STATE STREET CAMPUS GARAGE MADISON, WI 20448

OWNER:	CITY OF MADISON
From ARCHITECT:	EPPSTEIN UHEN ARCHITECTS, INC
To CONTRACTOR	STEVEN'S CONSTRUCTION
DATE OF ISSUANCE:	12/19/2023

This is not a CHANGE ORDER or a DIRECTION TO PROCEED with the work described in the proposed modifications.

1 FOUNDATION PLAN - ZONE B - PHASE 1
S1000-B-1 SCALE: 1/8" = 1'-0"

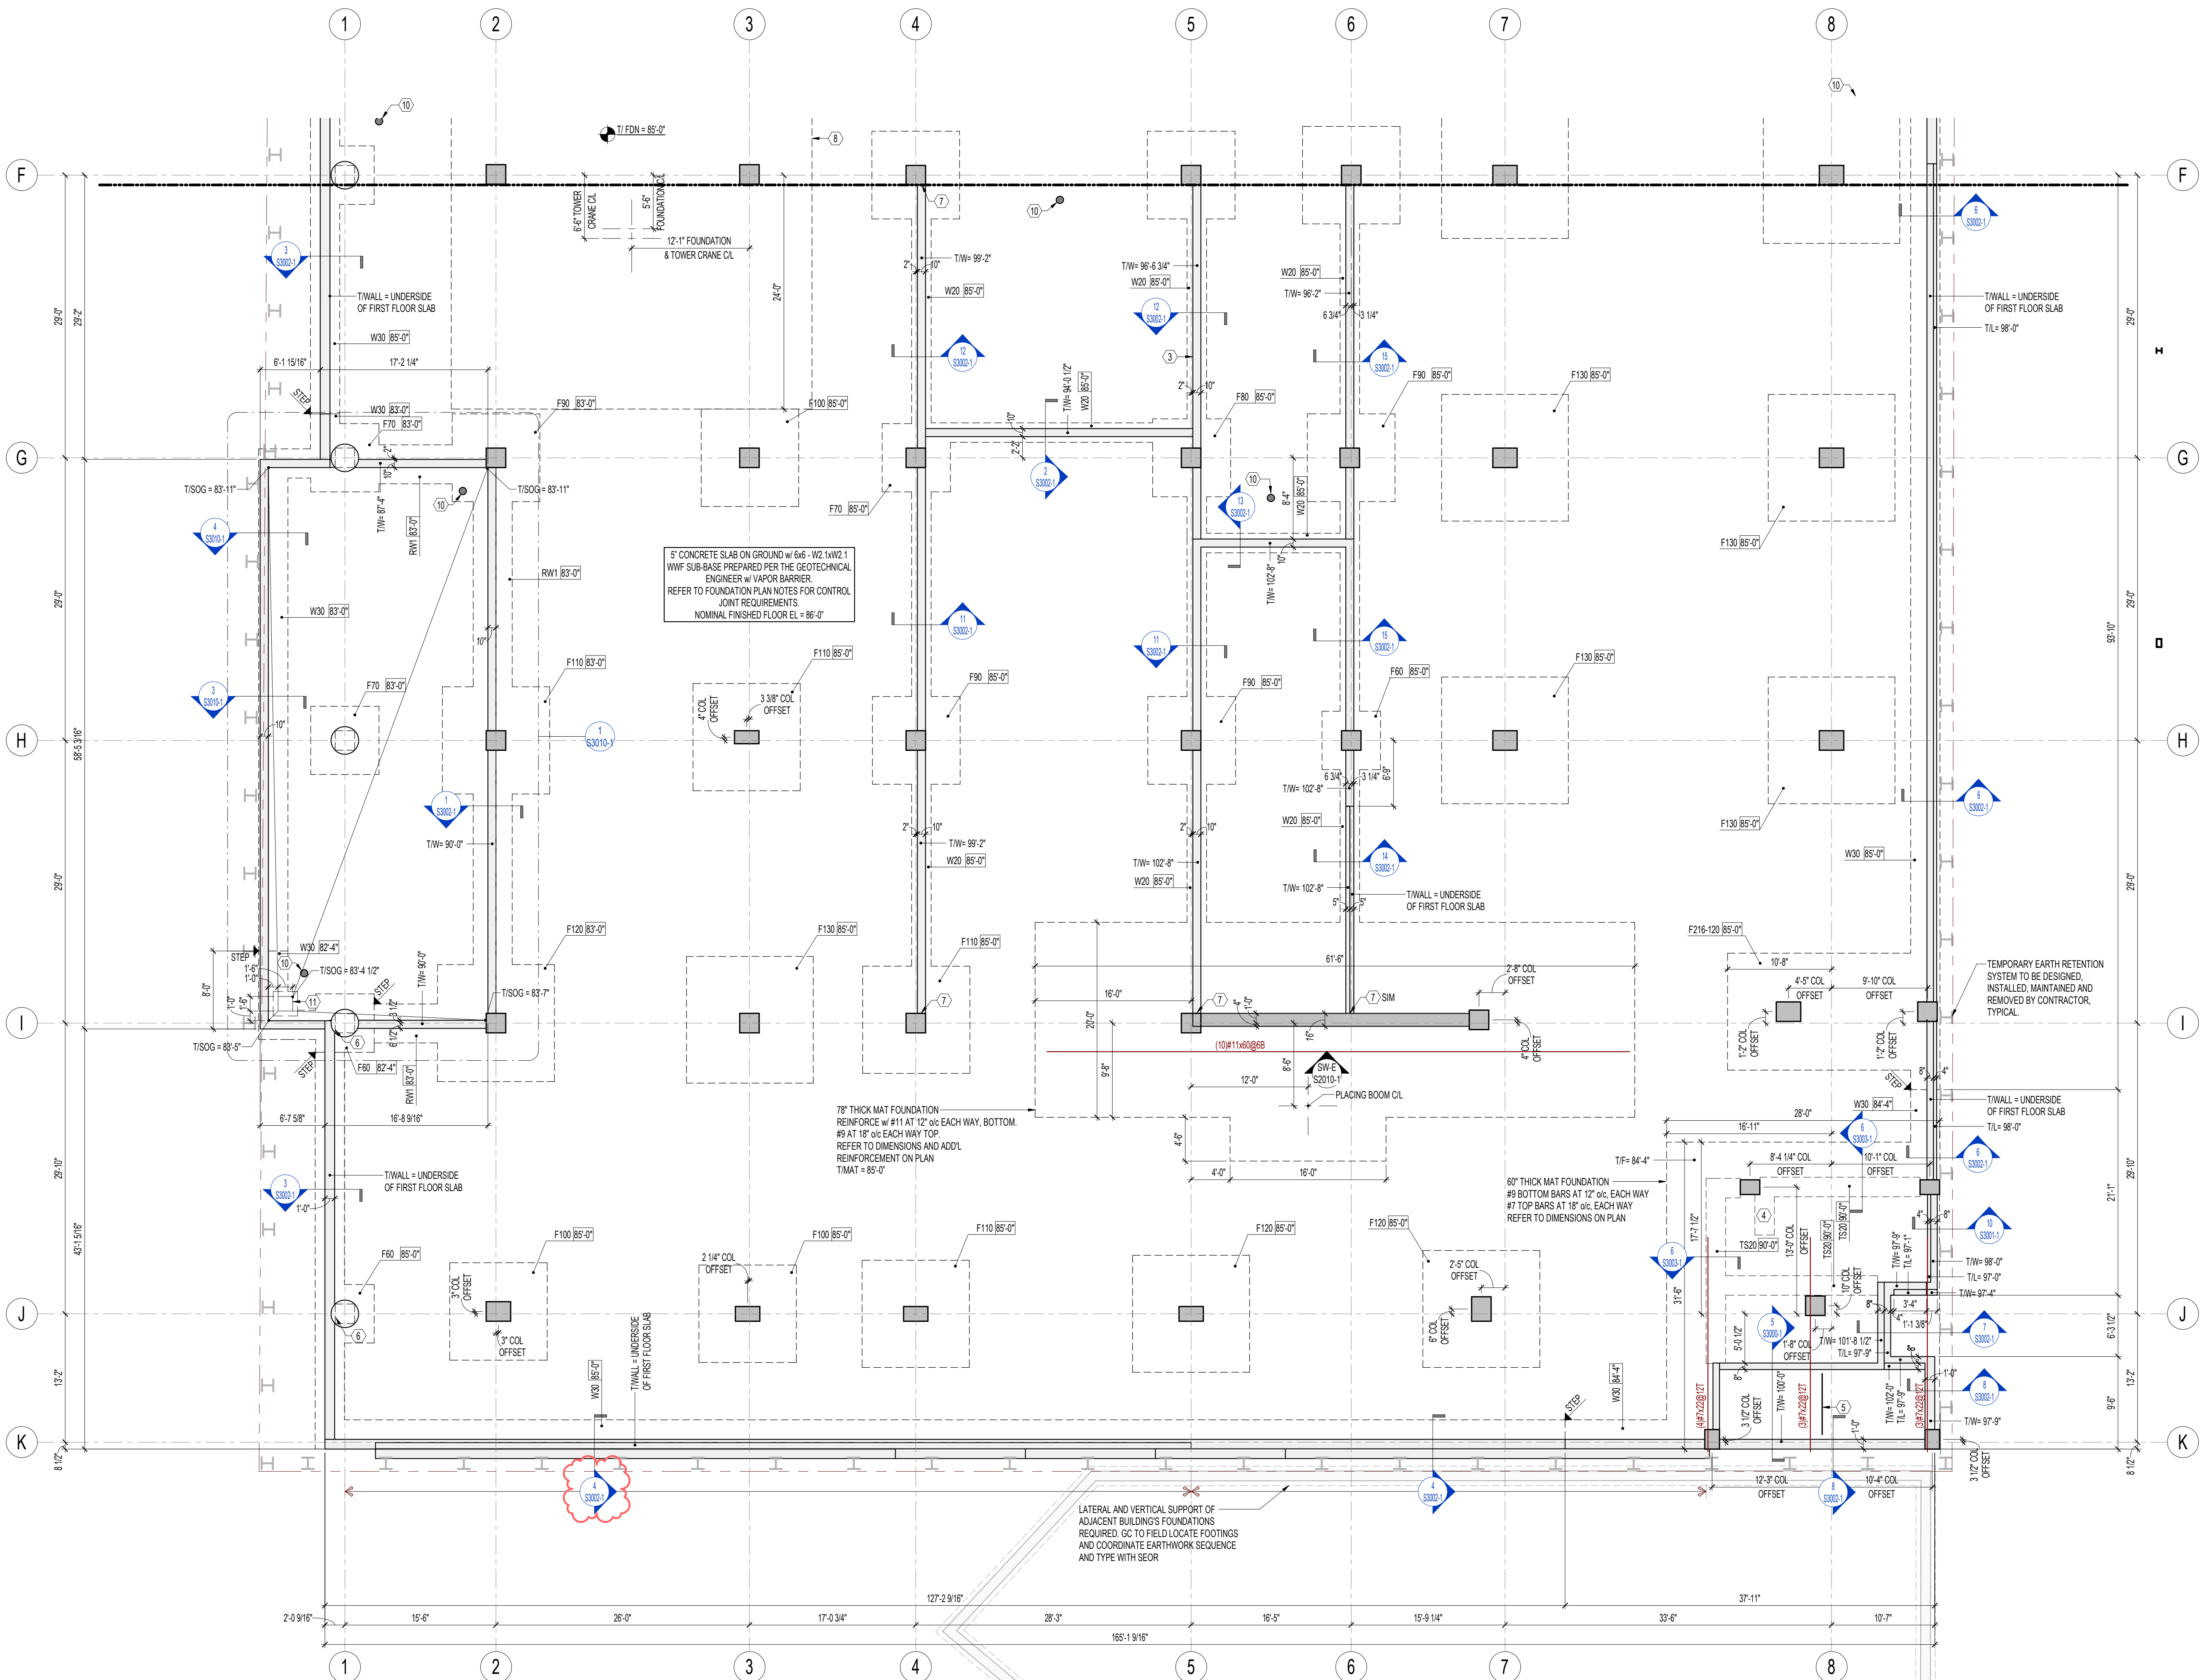
S1000-B-1 FOUNDATION PLAN – ZONE B – PHASE 1
REVISE COLUMN LOCATION AT GRIDS J-2

S1000-B-1 FOUNDATION PLAN – ZONE B – PHASE 1
ADD DETAIL SECTIONS TO INTERIOR FOUNDATION WALLS AT RAMPS
ADD WALL/COLUMN ISOLATION KEYED NOTES
REVISE FOOTING AT GRID I/8
REVISE SOUTH WALL STRIP FOOTING LOCATIONS FOR EARTH RETENTION
REVISE MAT FOOTING LOCATION/DIMENSIONS AT SOUTHEAST CORNER FOR EARTH RETENTION
DELETE FOUNDATION WALLS AT STAIR SHAFT CMU
ADD THICKENED SLABS AND DETAIL AT STAIR SHAFT CMU
REVISE RETAINING WALL WIDTH AT ELECTRICAL VAULT
REVISE RETAINING WALL FOOTING WIDTH AT ELECTRICAL VAULT
ADD TOP WALL ELEVATIONS TO RETAINING WALLS AT ELECTRICAL VAULT
REVISE SHEAR WALL E AND MAT FOOTING LOCATION **(PH2)**
ADD TOWER CRANE FOUNDATION **(GC)**
ADD JOG TO MAT FOOTING AT SHEAR WALL E **(GC)**

1 1ST FLR FRAMING PLAN - OVERALL - PHASE 1
S1001-1 SCALE: 1/16" = 1'-0"

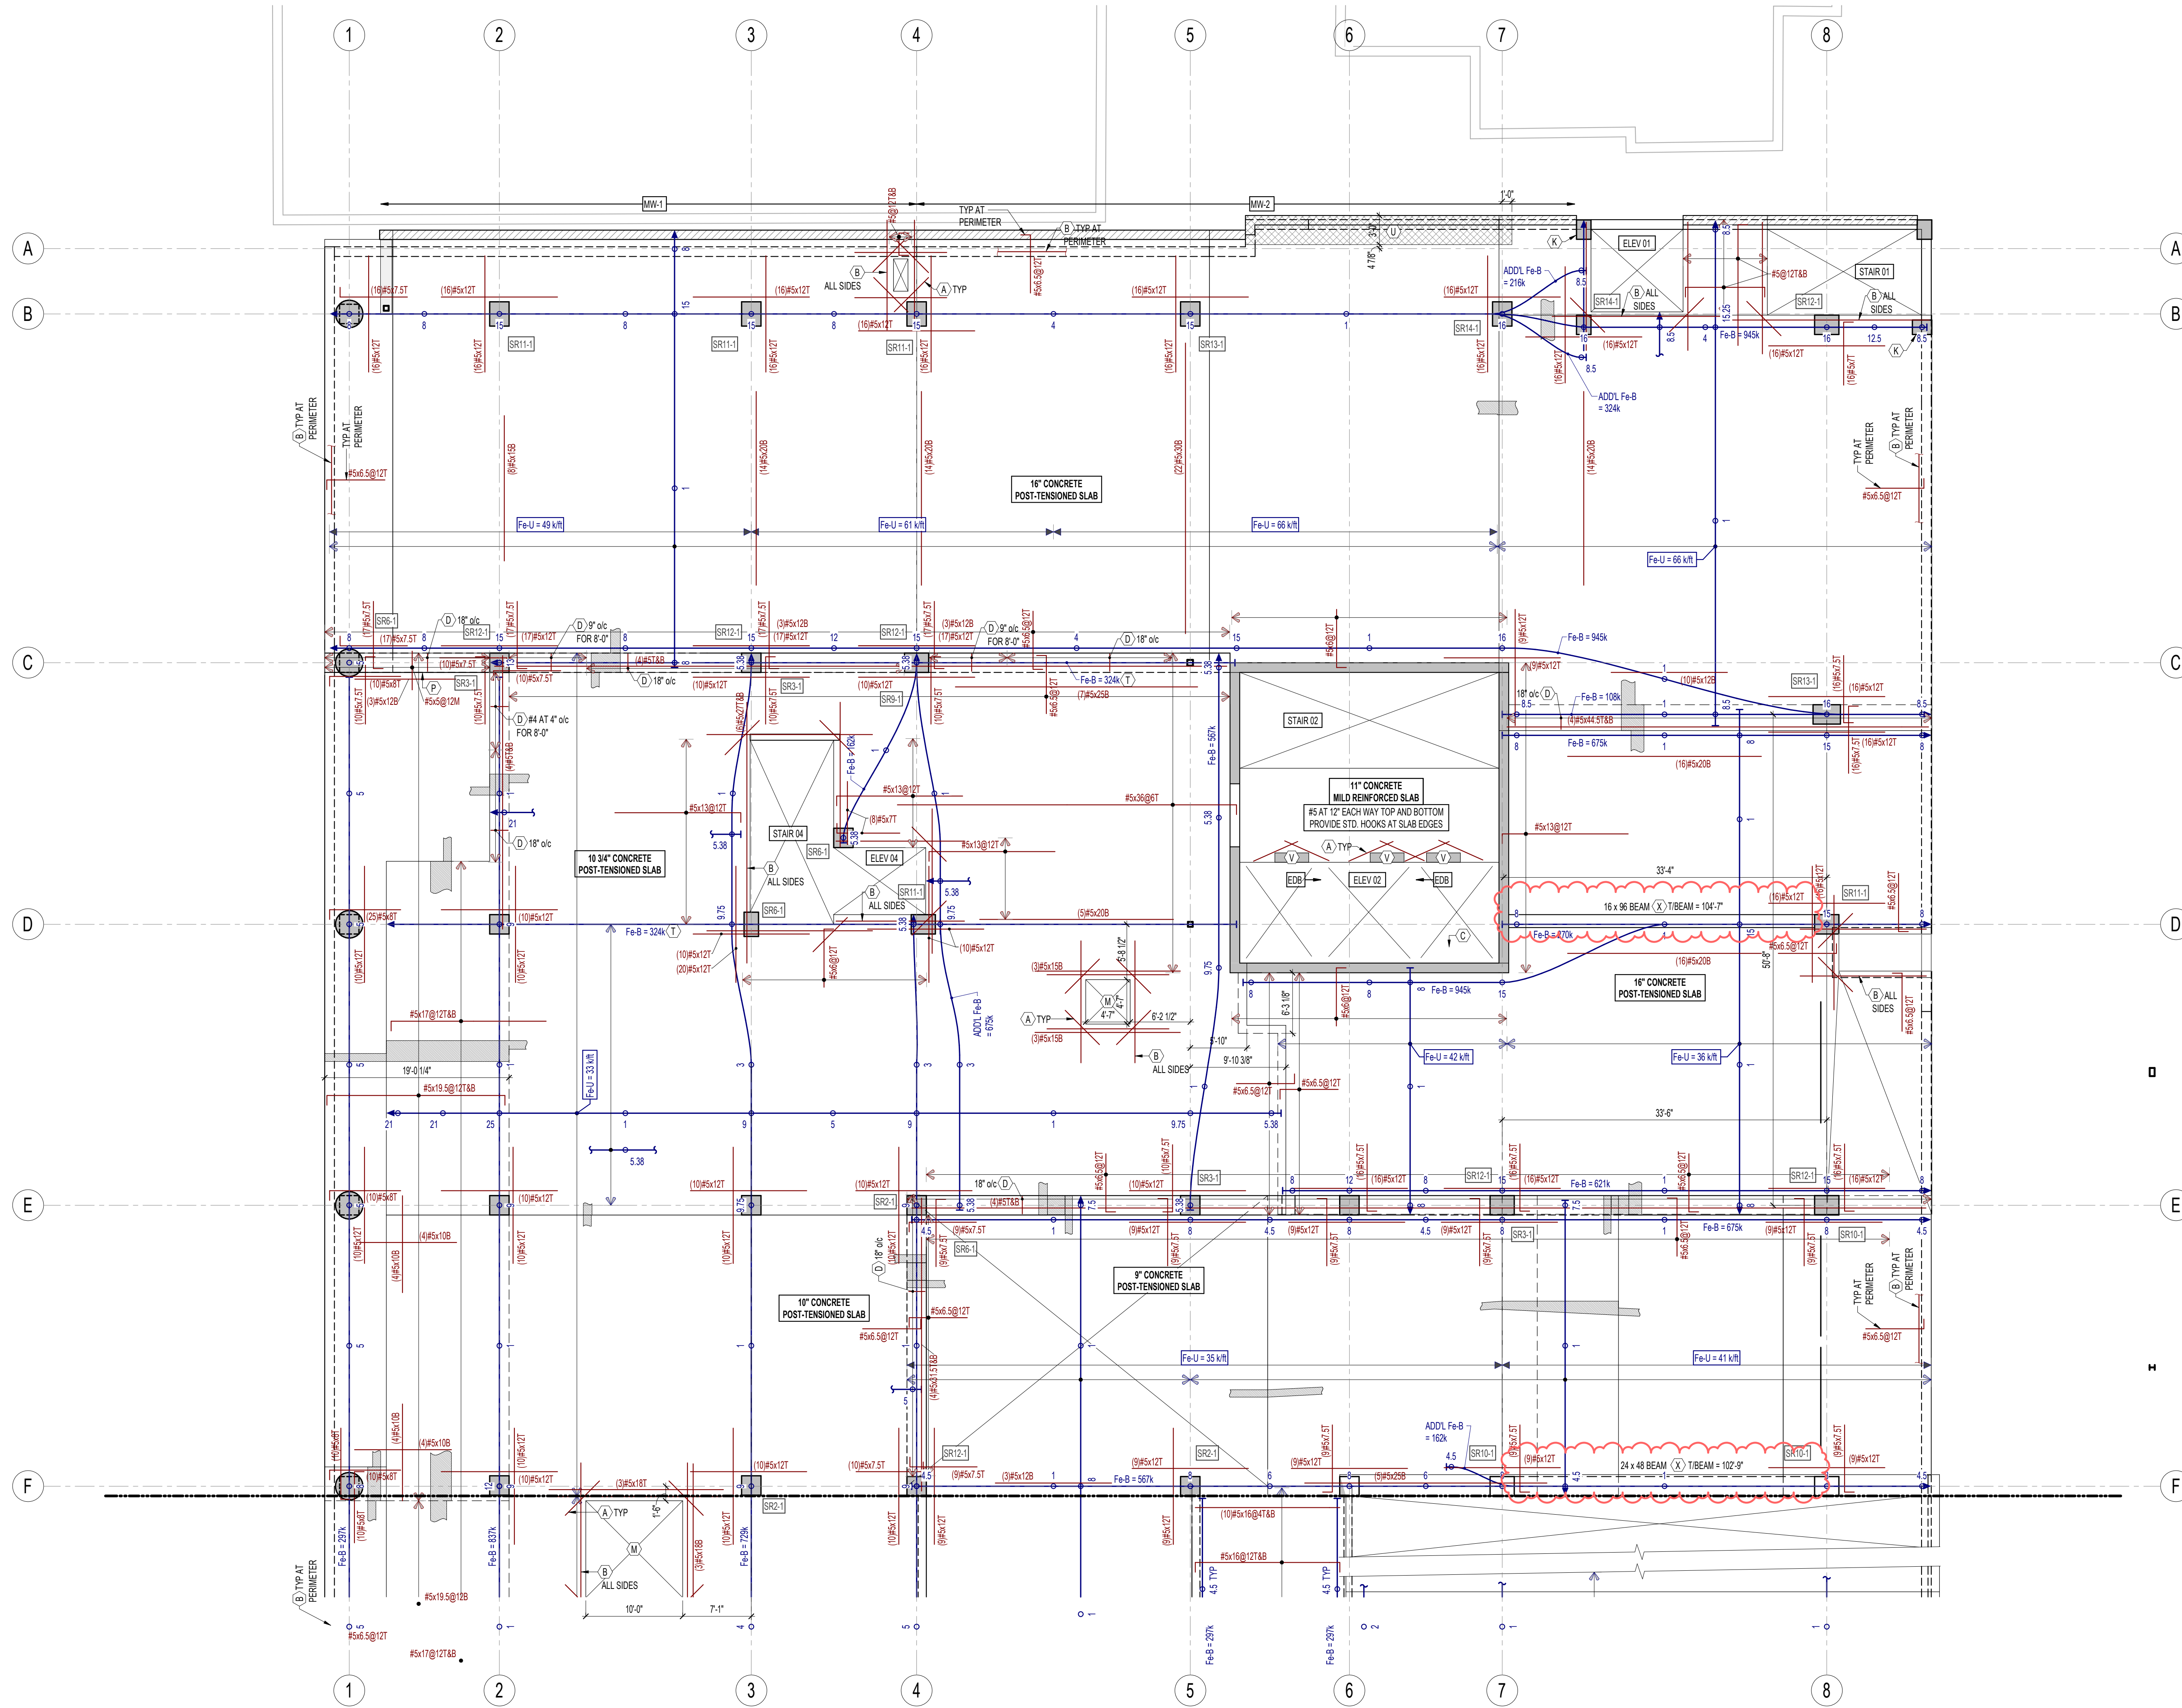
S1001-1 1ST FLR FRAMING PLAN – OVERALL – PHASE 1
ADD DETAIL 8/S3001-1 SECTION FOR STOOP AT NW CORNER
REVISE SLAB THICKNESS
ADD NOTE AND SLAB DIAGRAMS FOR 14" SLAB
REVISE SLAB DIAGRAM DIMENSION AT GRID I
ADD SHADED REGIONS WITH KEYED NOTE "G" FOR SLAB DEPRESSIONS

S1001-1 1ST FLR FRAMING PLAN – OVERALL – PHASE 1
ADD 3 ½" TOPPING SLAB NOTE AT BUS WAITING
REVISE 8" TOPPING SLAB NOTE AT BUS LANE
ADD KEYED NOTE L TO PLAN
REVISE SLAB DIAGRAM DIMENSION AT GRID F/3
ADD NOTATIONS FOR SUNKEN "TROUGH" SLAB AT GRID D/8
ADD SLAB SLOPING NOTE AT SOUTHWEST ENTRY

S1001-1 1ST FLR FRAMING PLAN – OVERALL – PHASE 1
ADD HATCH FOR PHASE 2 TOPPING SLAB
REVISE SLAB ELEVATION AND STEP AT NORTHWEST EXIT
ADD DETAIL SECTIONS

S1001-1 1ST FLR FRAMING PLAN – OVERALL – PHASE 1
REVISE SLAB SLOPE AT NW BUS EXIT
ADD HSS BEAM AND DETAIL AT BUS WAITING
ADD DETAIL CUT 4/S4002-1 (2 LOCATIONS)
REVISE OPENING LOCATION FOR ELECTRIC VAULT GRATES

S1001-1 1ST FLR FRAMING PLAN – OVERALL – PHASE 1
REVISE SLAB SLOPE AND ELEVATIONS AT EAST GARAGE ENTRANCE
ADD DETAIL 12 AT SLAB/FOUNDATION WALL ON EAST SIDE
REVISE WALL EXTENTS AT STAIR 4 AND ADD DETAIL CUT
